PREVOST

**SAFETY
RECALL**

Sr05-06

DATE : May-2005	SECTION : 16
SUBJECT : IMPROPER MOUNTING OF 3 RADIUS ROD SUPPORTS

FIGURE 3: REAR SUSPENSION

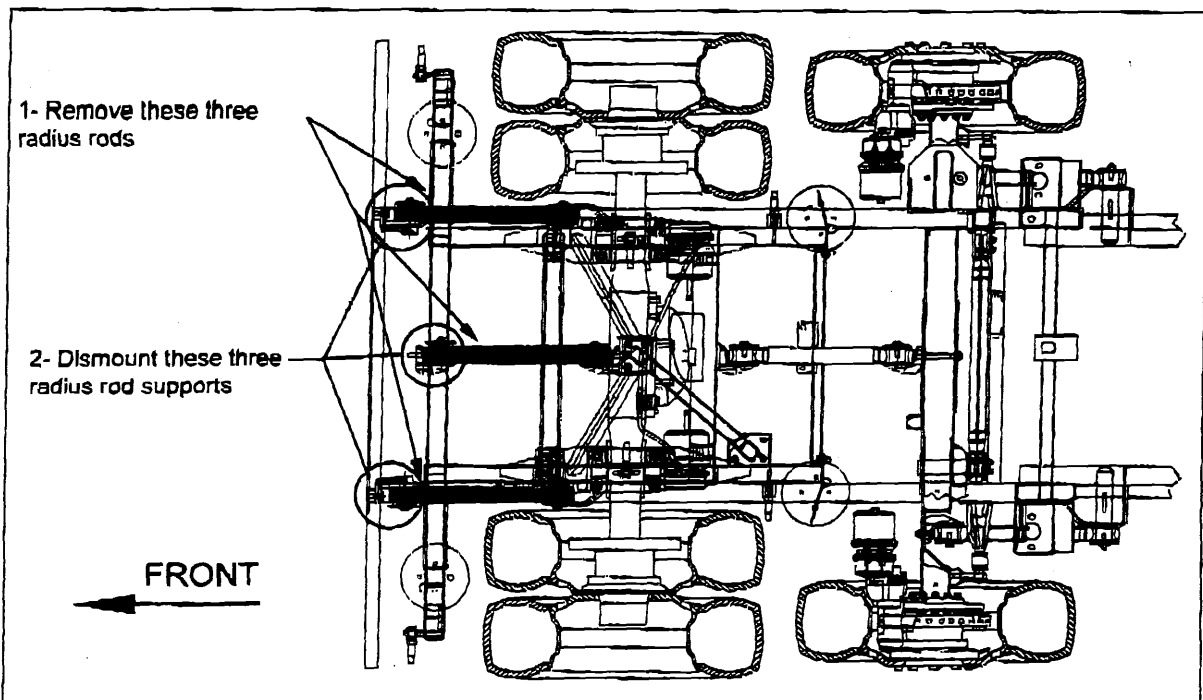
For the above mentioned vehicles, PrevoSt Car has determined that a too large quantity of anti-seize compound has been used for mounting the 3 identified radius rod supports. The bolts securing the supports could come loose and the support may eventually detach from the structure. This could affect vehicle stability and cause a crash. It is necessary to dismount the radius rod supports, to remove all trace of anti-seize compound and to reinstall the supports according to the corrected factory procedure.

5. Dismount successively the 3 radius rods identified in figure 3 by flattening the tabs of locking plate and by unscrewing the two bolts directly fastened into radius rod pivot (if needed, refer to maintenance manual).

6. Dismount successively the 3 radius rod supports identified in figure 3. Take note of the position and quantity of shims in order to reinstall the components in the same condition as they were to maintain proper vehicle alignment.

FIGURE 4: SUPPORT CLEANING (typ. 3 supports)

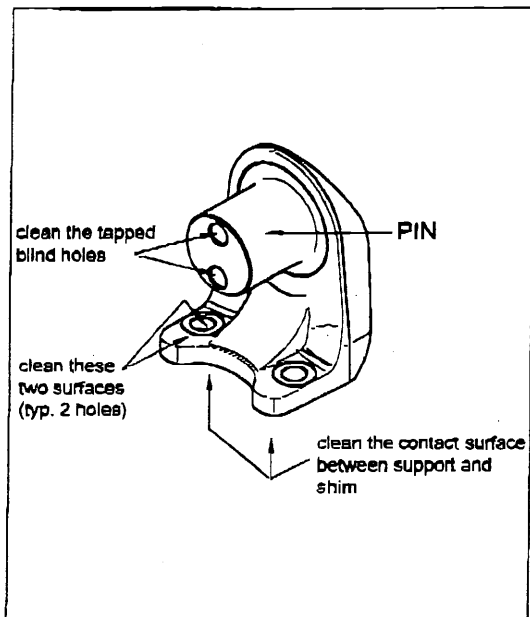
7. Using brake cleaner, thoroughly clean the 3 supports contact surfaces to remove all trace of anti-seize compound. Clean the contact surfaces between support, shim and structure. On supports (see figure 4), clean the contact surface of the bolt head, the passing holes and use brush #684901 to clean the tapped blind holes. Use brake cleaner and a clean clothe to dry.

FIGURE 5: CLEANING OF 2 PINS AND THE CENTRAL SUPPORT PIN

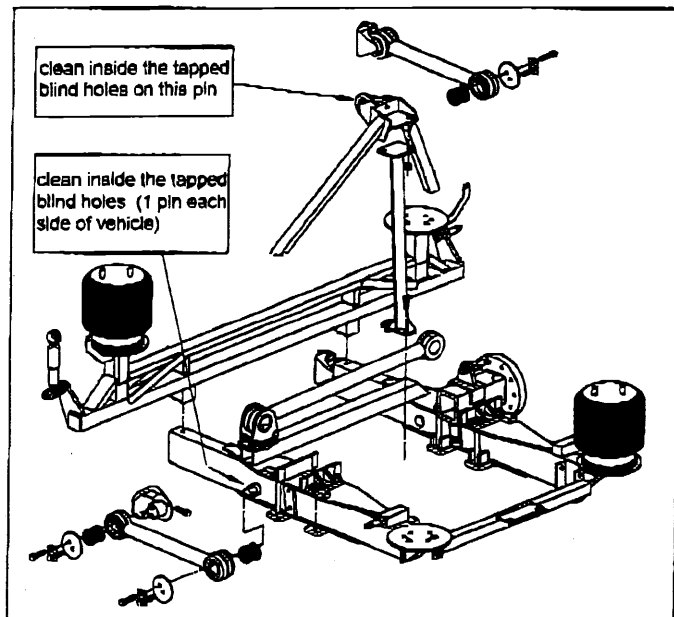
8. Clean inside the 6 tapped blind holes where the supports are bolted. Use brake cleaner, brush #684901 and a clean clothe to dry.
9. Clean inside the tapped blind holes of the 3 support pins identified in figure 5. Use brake cleaner, brush #684901 and a clean clothe to dry.

FIGURE 6: REAR SUSPENSION

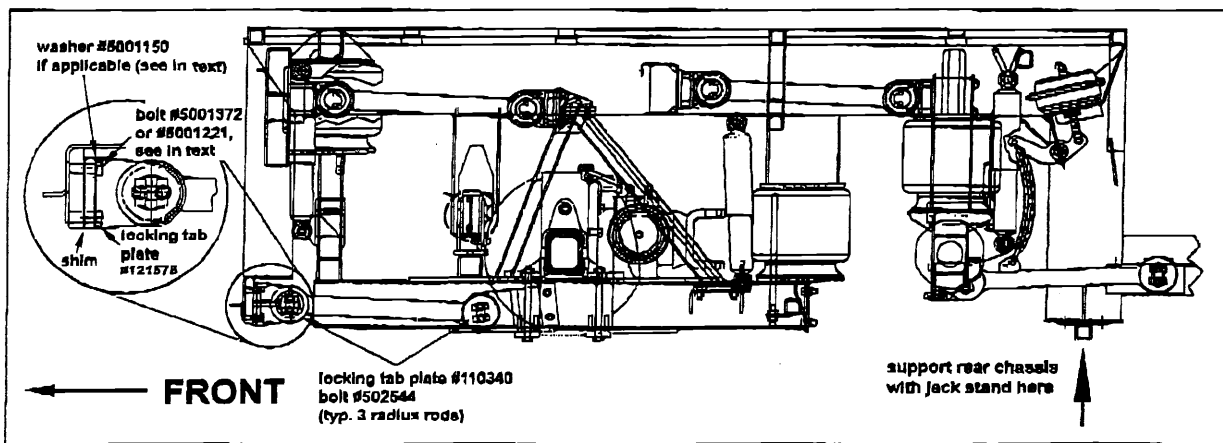
10. Reinstall the supports (figure 6). Do not forget to reinstall the shims correctly.

- Use 2 new bolts (#5001372) per support. If your vehicle is included in the range beginning from 2PCW3349451028407 up to 2PCW3349X51028461 inclusively, you must use bolts #5001224 instead.
- Use new tab locking plates (Prevost #121578).
- For the outer left and right supports, you must use new washer (#5001150) if the total thickness of their respective shims is less than 1/8" (3mm).
- Put 3 drops of Loctite 243 (Prevost #680038) in each of the 6 tapped blind holes and a line of Loctite on bolts.
- Tighten bolts to a torque of 185-205 lbf-ft.

11. Fold locking tab over bolt heads.
